# RFB-2022-20 PRINCETOWN SHERIFF'S SUBSTATION RENOVATIONS & NEW CONSTRUCTION C2 DESIGN GROUP

## **ADDENDUM #3**

Issued Date: 03/08/2022

A100-L SCALE: 1/4" = 1'-0"

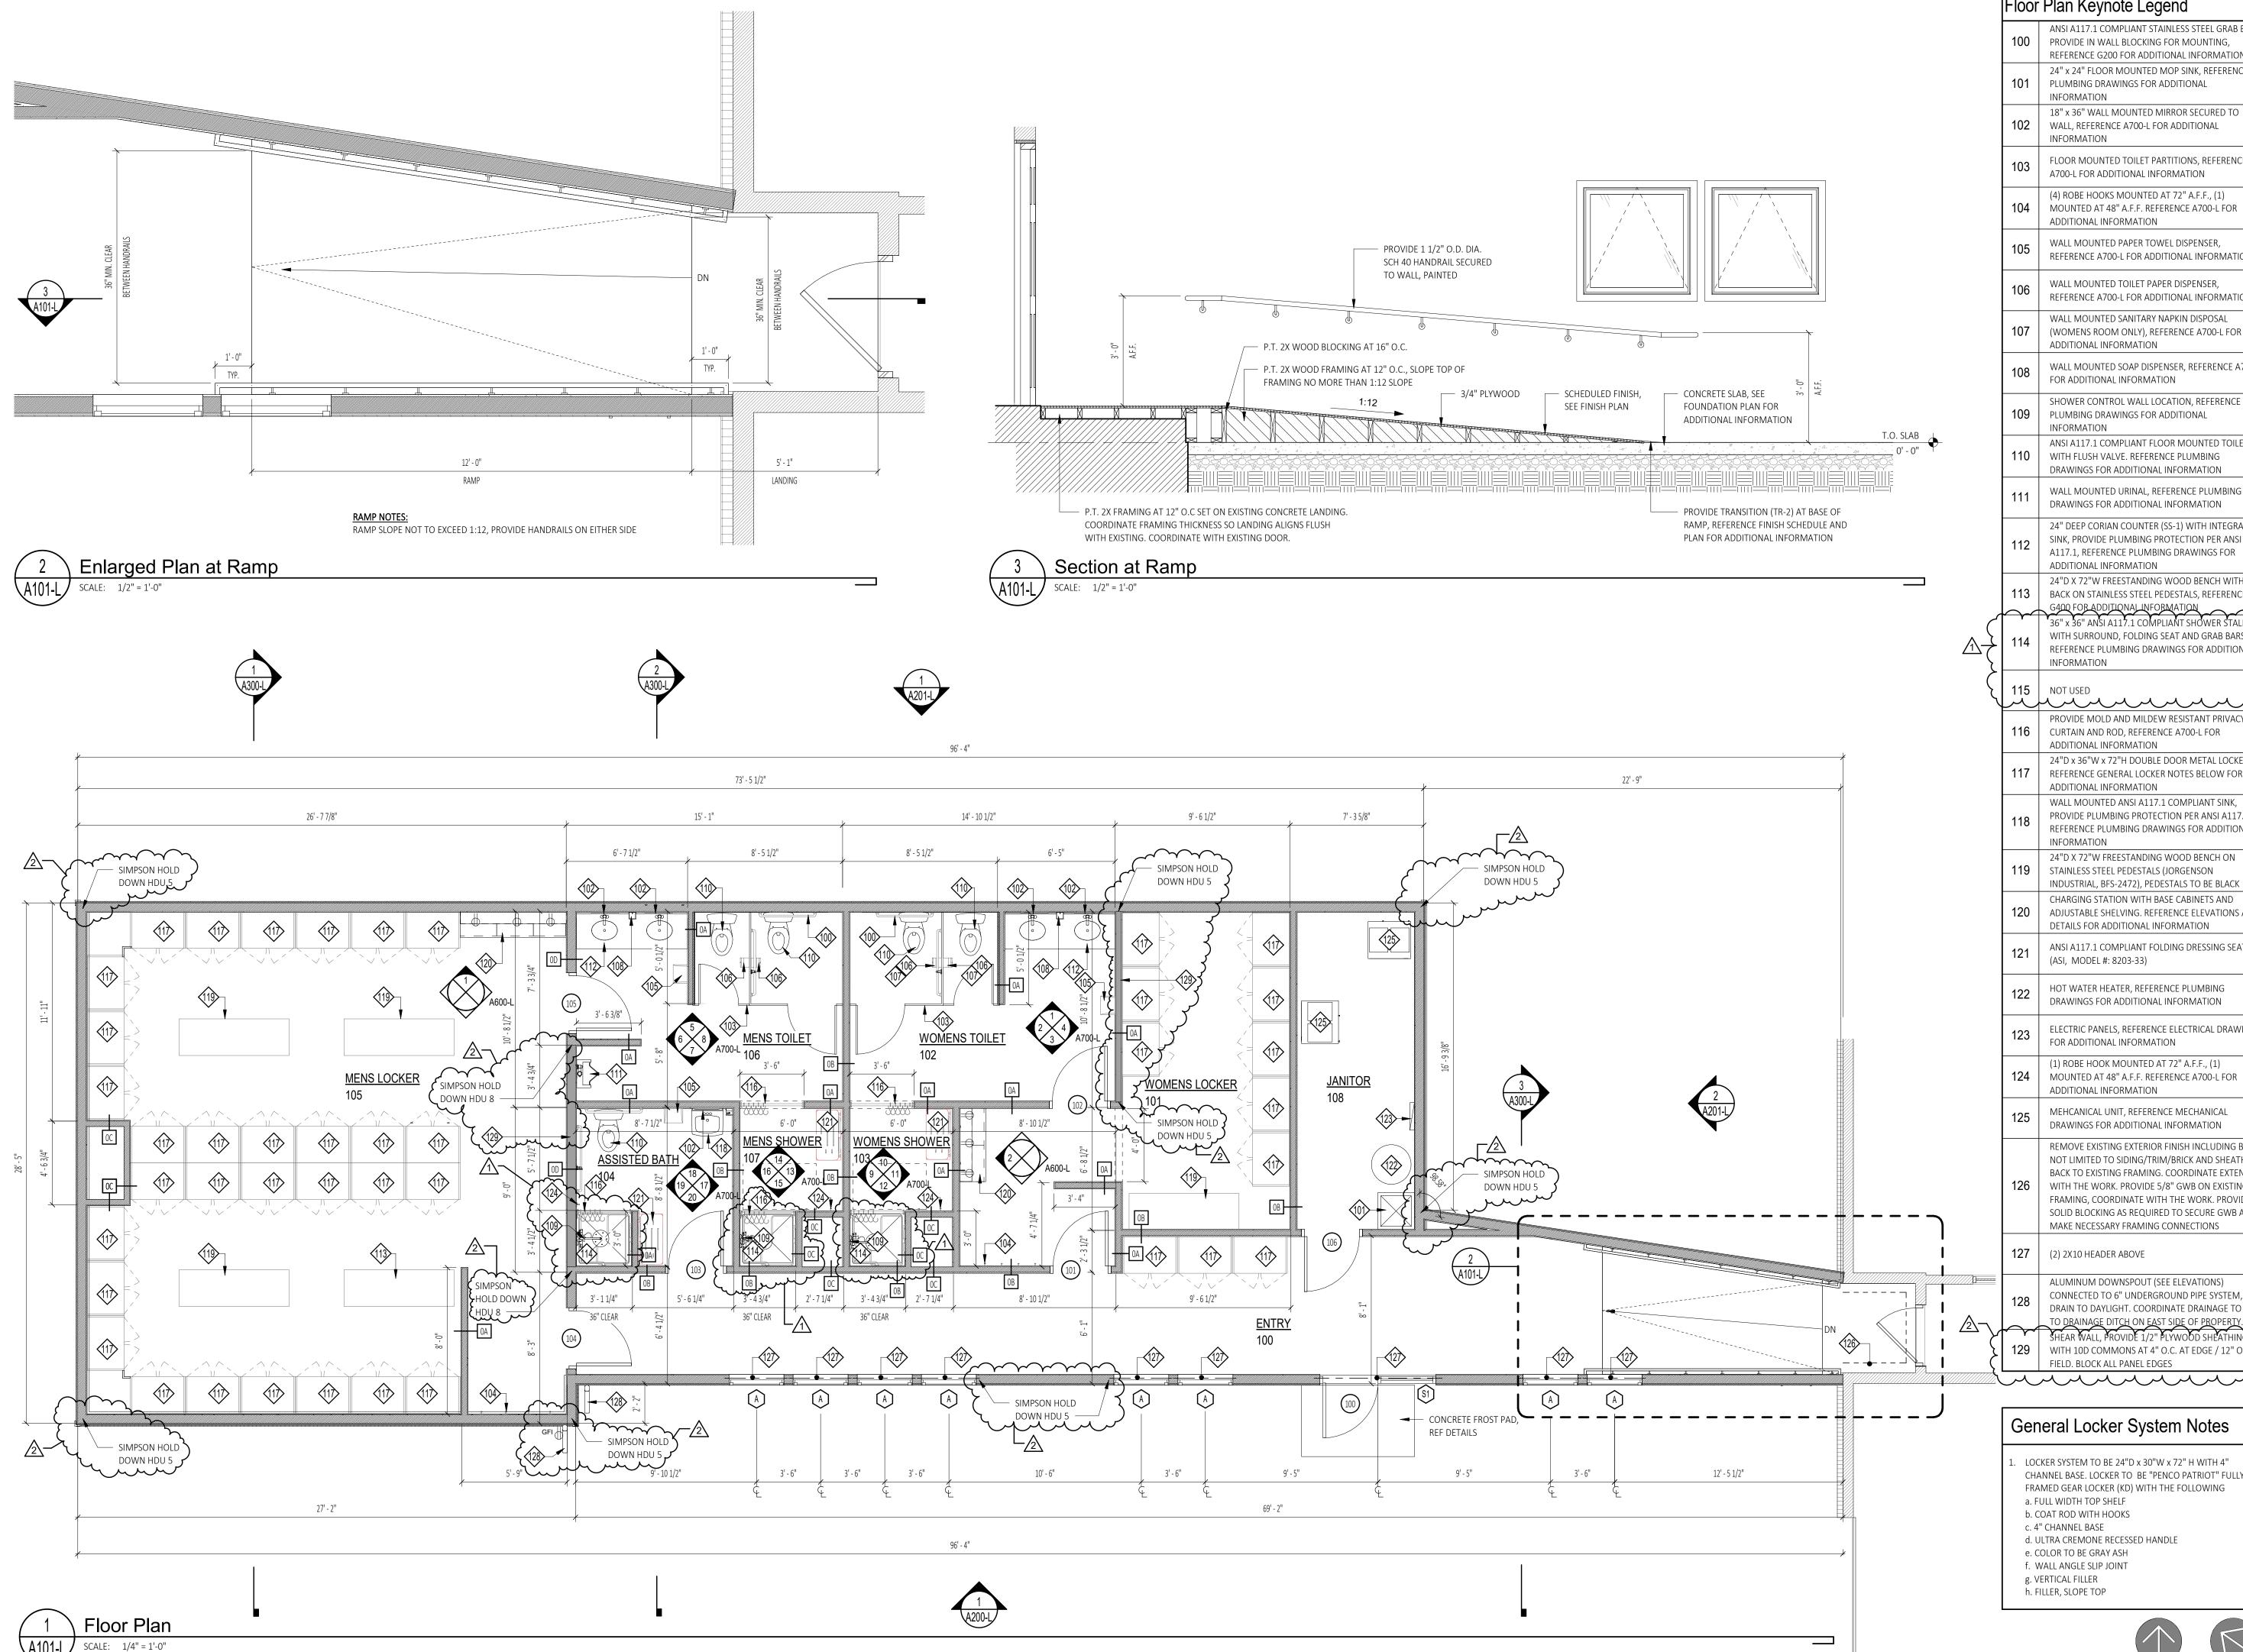
Shear wall locations and information has been provided on sheets A100-G, A600-G, A100-L, A101-L and A500-L.

1 Typical Wall Section
A500-L SCALE: 3/4" = 1'-0"

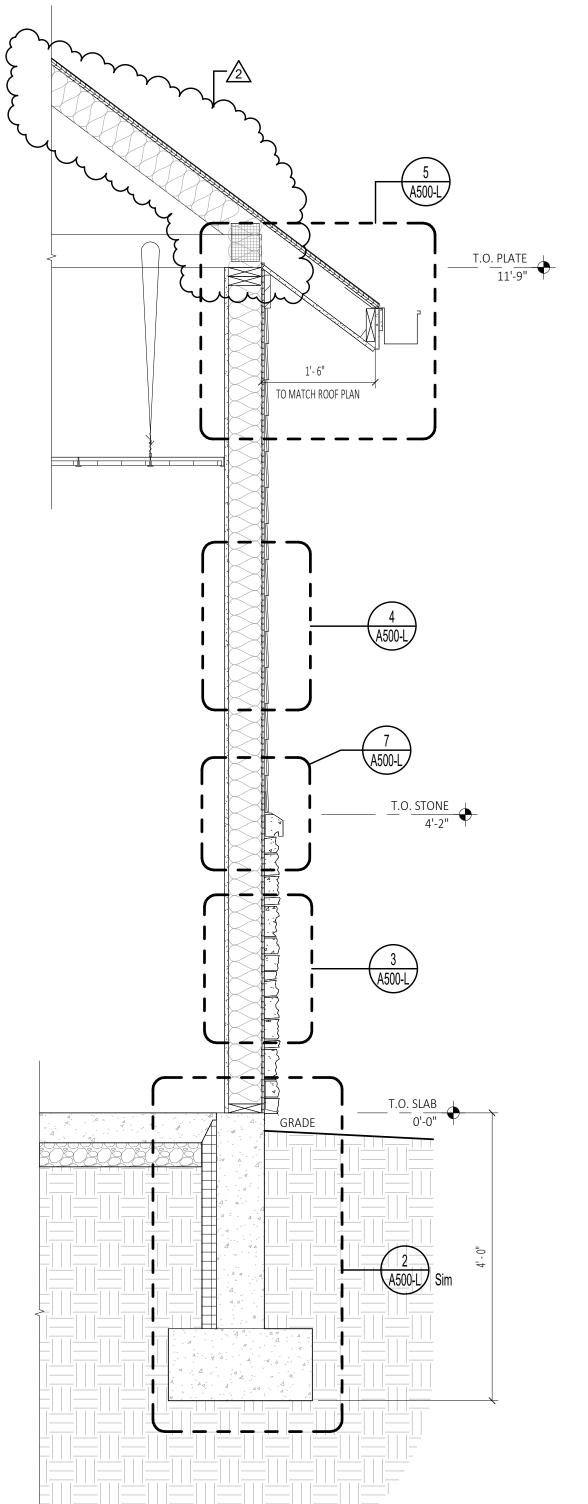
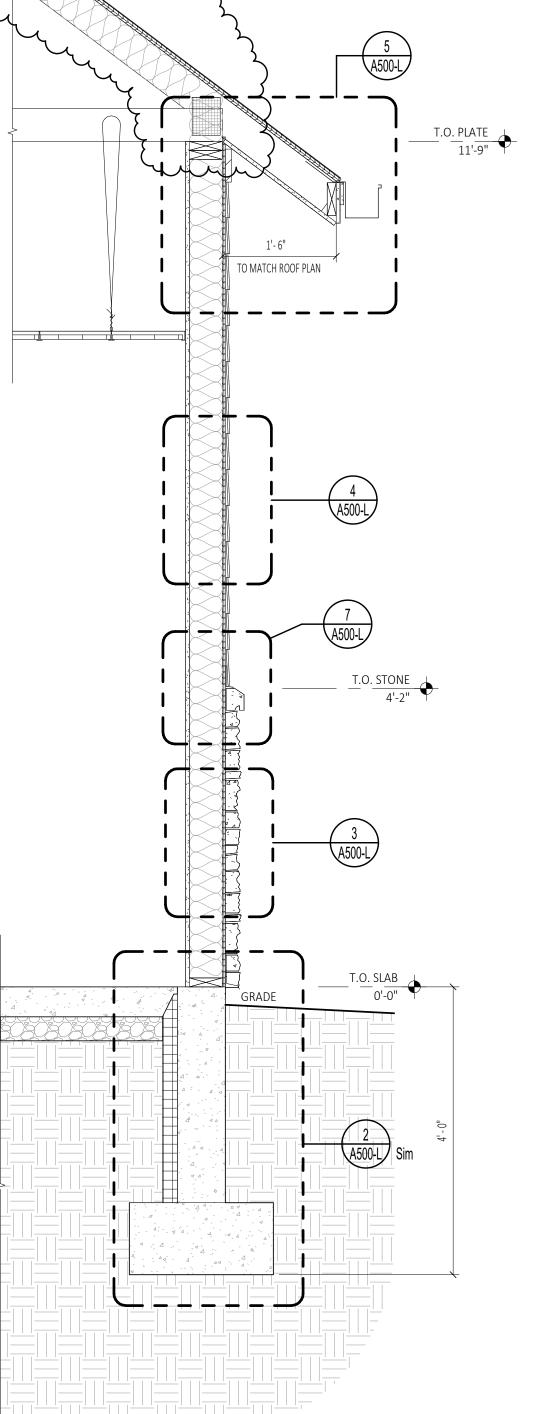
The roof insulation has been updated to match the correct locations based on the sections / details. See sheet A500-L for clarification.

A800-L SCALE: 1/4" = 1'-0"

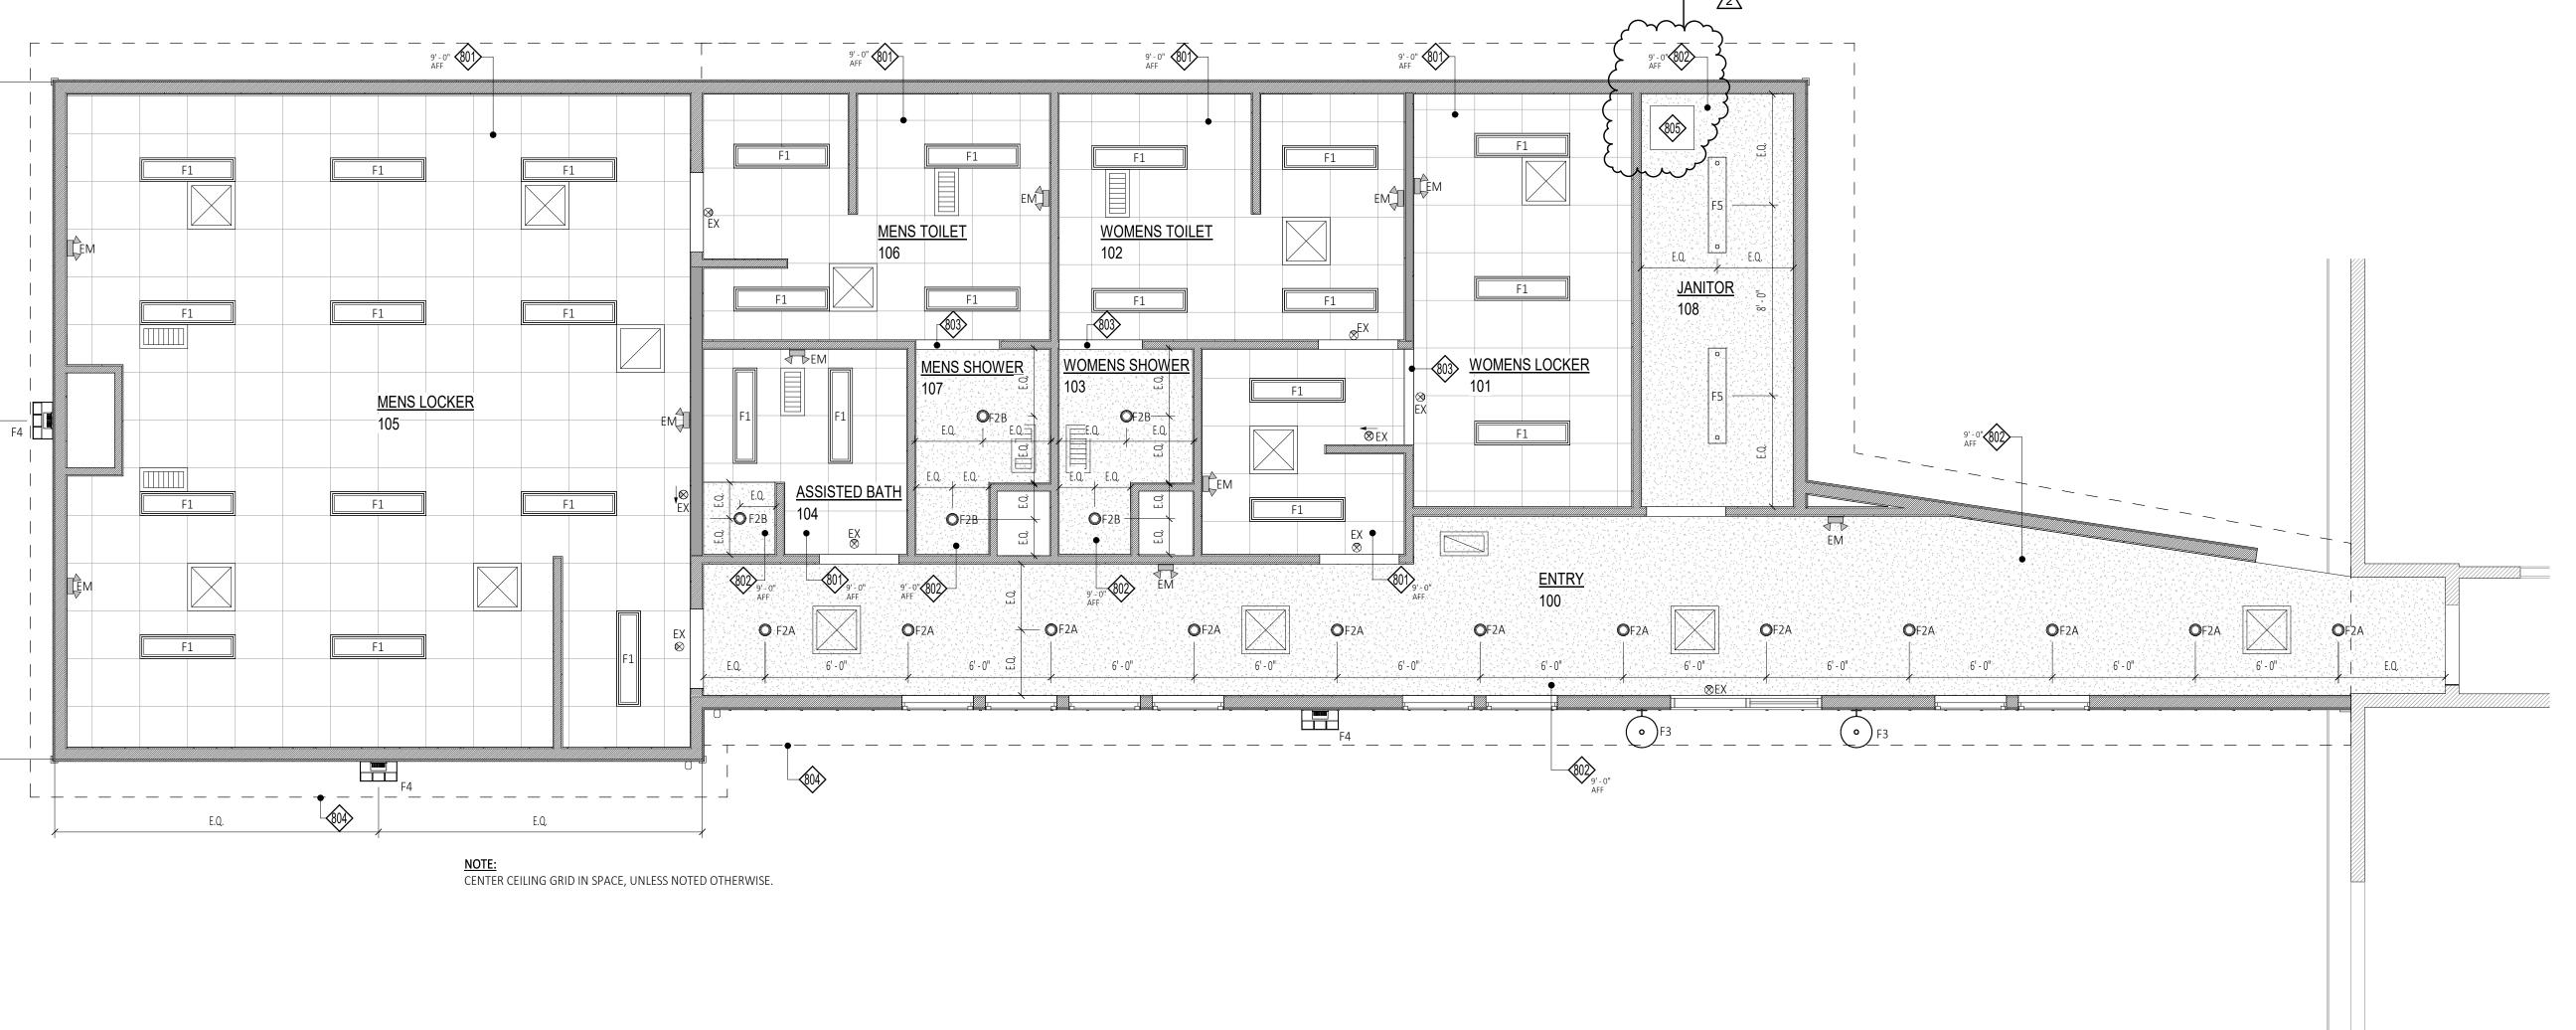
The ceiling plan for the Locker Building on sheet A800-L has been revised to show a GWB ceiling with an access hatch.
